Application Reference No. 21/01251/FUL

**Proposed Development at 7 Hawkwell Park Drive, SS5 4HA
Impact on 1 Park Gardens, Hockley SS5 4HE**

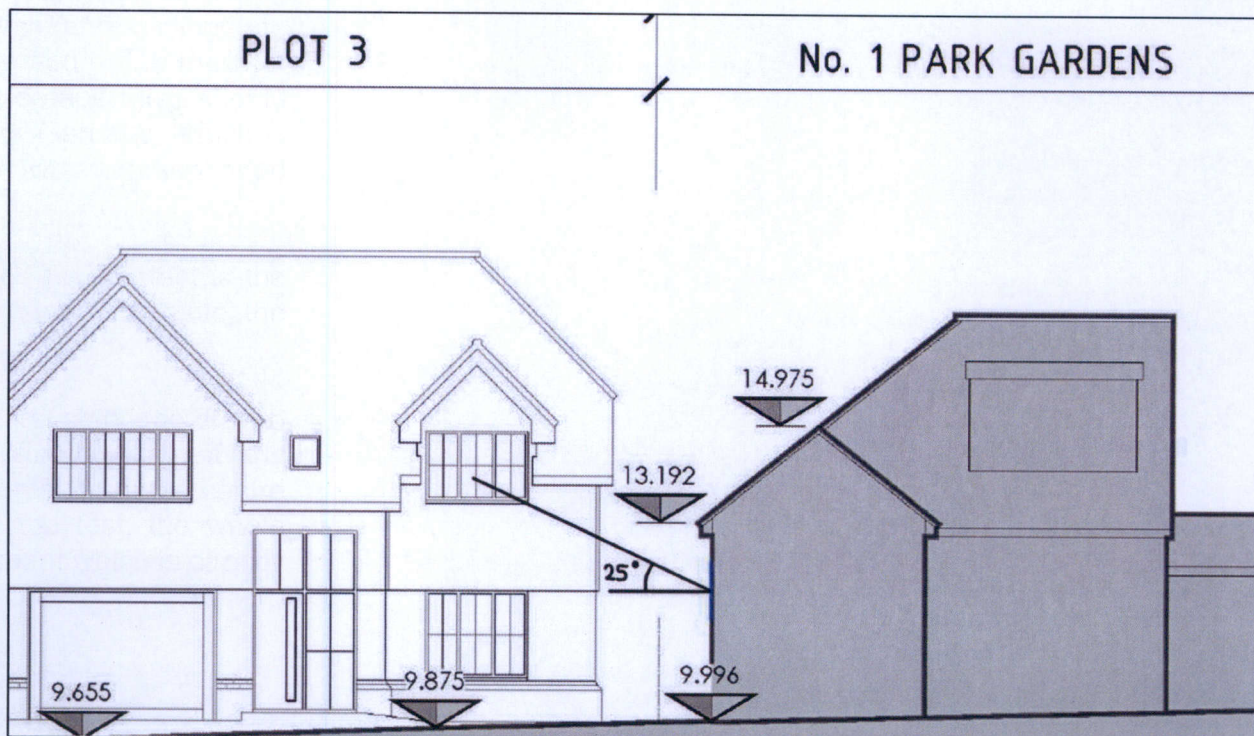
Using the proposed street elevation planning drawings, we have been able to plot the approximate position of the centre of the window in question. It is evident from the drawing overleaf that the proposed extension does not satisfy the 25° test, and by a significant margin.

Although the proposed extension does not satisfy the preliminary 25° test, it does not always follow that daylight and sunlight will be adversely affected, although it would seem that in this instance given the proximity and height of the plot 3 relative to our client's boundary that daylight and sunlight will be adversely affected with respect to any side windows at the property.

In any case, breaching the test signifies that further detailed tests are needed. We would therefore expect the council to require the applicant to carry out an assessment in accordance with the BRE guide. The assessment should include the following tests:
